COUNCIL ASSESSMENT REPORT

Panel Reference	PPSSEC-83
DA Number	DA-482/2017/A
LGA	Waverley
Proposed Development	Modification to construct two additional residential levels, provide five additional apartments, internal alterations and changes to bicycle parking spaces, roof design and façade
Street Address	57-75 Grafton Street, BONDI JUNCTION
Applicant/Owner	Clygen Pty Ltd
Date of DA lodgement	18 August 2020
Total number of Submissions	• Twelve
Number of Unique Objections	• Twelve
Recommendation	Refusal
Regional Development Criteria (Schedule 7 of the SEPP (State and Regional Development) 2011)	Development that has a capital investment value of more than \$30 million.
List of all relevant s4.15(1)(a) matters	<ul style="list-style-type: none"> • State Environmental Planning Policy 55 - Remediation of Land • State Environmental Planning Policy 65 - Design Quality of Residential Flat Development • State Environmental Planning Policy (Building Sustainability Index: BASIX) 2004 • State Environmental Planning Policy (Infrastructure) 2007 • State Environmental Planning Policy (State and Regional Development) 2011 • State Regional Environmental Plan (Sydney Harbour Catchment) 2005 • Waverley

Figure 7: View 2 (RL 63.7) comparison between the approved (left) and proposed (right)

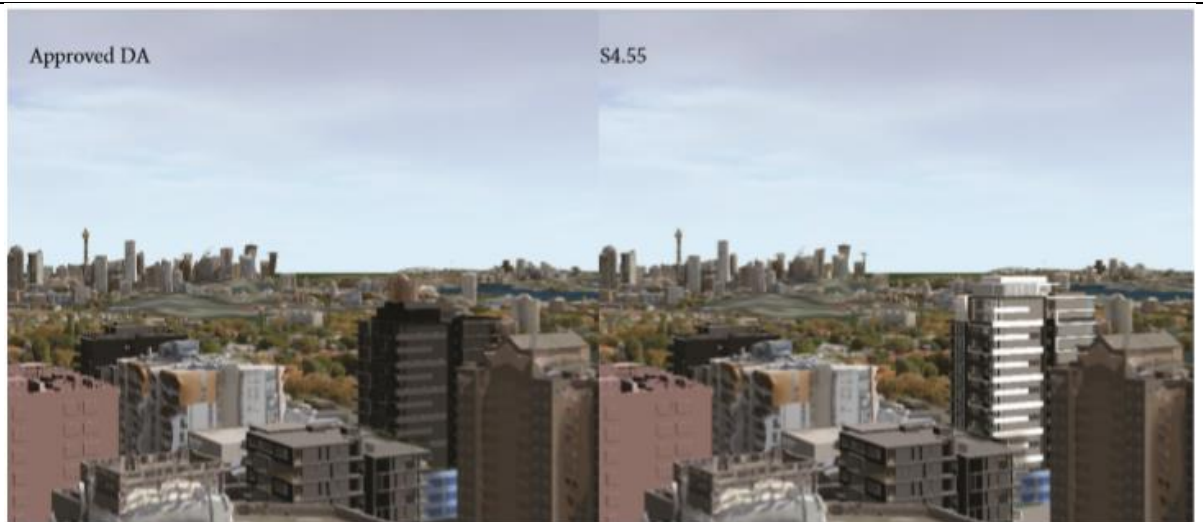
The proposed additional levels will not impact upon views from properties directly to the rear of the site, as these are lower in height than the additional levels. Notwithstanding, Council's 3D digital modelling reveals that views containing icons will likely be impacted from 71-73 Spring Street, a high-density development to the south-east of the site. **Figures 5-8** provide an indication of the views that will likely be impacted from the upper levels of this building.

This planning principle is considered particularly relevant to the subject modification, as the 3D modelling clearly indicates that a compliant development (even with the variation to the height development standard as approved) retains the iconic views from these apartments. The view impacts are a direct result of the additional two levels being sought. The two levels are in excess of both the height and FSR development standards and in this regard, the view loss is considered unreasonable.
